# **HOLDOVER**

## ***REVISED***

### **LYDIA PLACE SUBDIVISION**

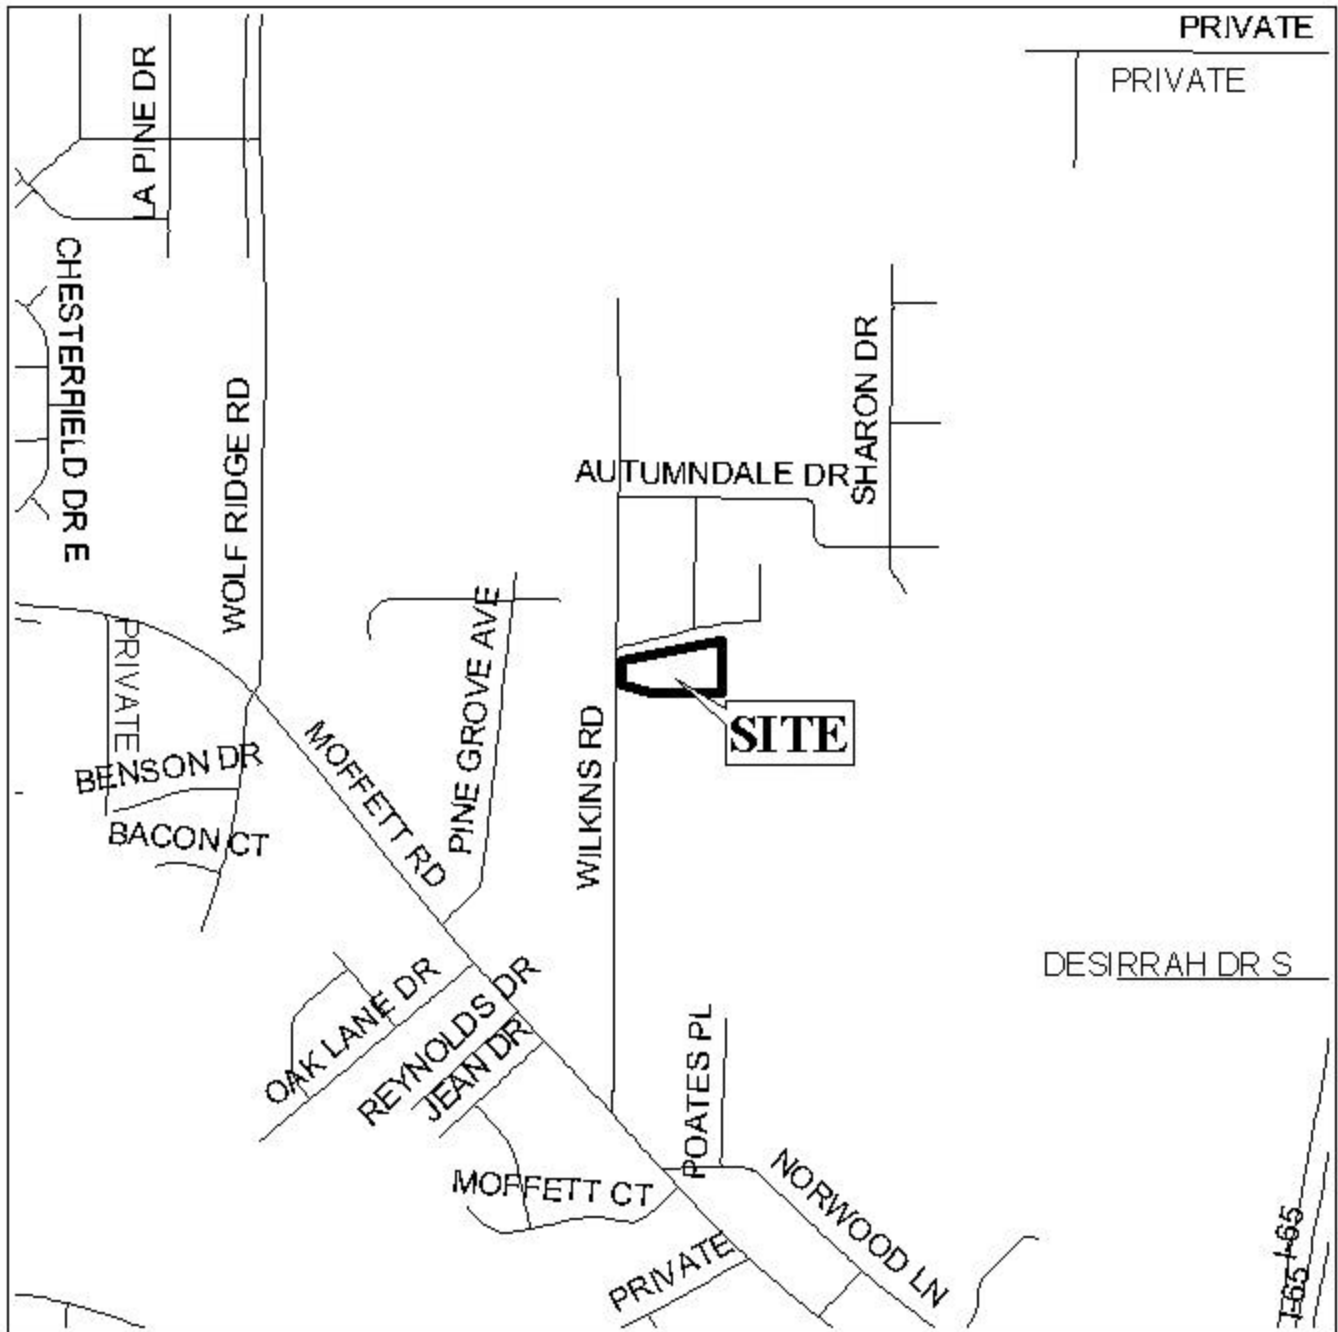
Engineering Comments: Stormwater detention required. Common Area for detention not shown on plat. Must comply with all stormwater and flood control ordinances. Any work performed in the right-of-way will require a right-of-way permit.

Traffic Engineering Comments: Driveway numbers, size, location and design to be approved by Traffic Engineering and conform to AASHTO standards.

The site fronts the former path of the Donald Street Extension of the Major Street plan; however, this proposed street extension has been removed from the Major Street Plan. Lydia Drive, which has an existing right-of-way of 40-feet, is a minor street, and as such requires a 50-foot right-of-way; therefore, the dedication of sufficient right-of-way to provide 25 feet from the centerline should be required.

With Lot 1 being a corner lot, the dedication of a 25' radius should be required. Also, as a means of access management, the placement of a note on the final plat stating that Lot 1 is denied access to Wilkins Road should be required.

*At the Commissions last meeting, concerns were raised about possible wetlands on the site. The Planning Commission heldover this application in order for the surveyor/engineer to delineate any wetlands or water features on the site. No additional information was submitted prior to mailout.*

The plat meets the minimum requirements of the Subdivision Regulations and is recommended for Tentative Approval subject to the following conditions: 1) the dedication of sufficient right-of-way to provide 25 feet from the centerline of Lydia Drive; 2) the dedication of a 25' radius at the intersection of Lydia Drive and Wilkins Road (from Lydia Drive dedication); and 3) the placement of a note on the final plat stating that Lot is denied access to Wilkins Road.

*Based upon the preceding, this application is recommended for denial for the following reason:  
1) the applicant failed to submit any documentation regarding the existence and location of wetlands or water related features on the site.*
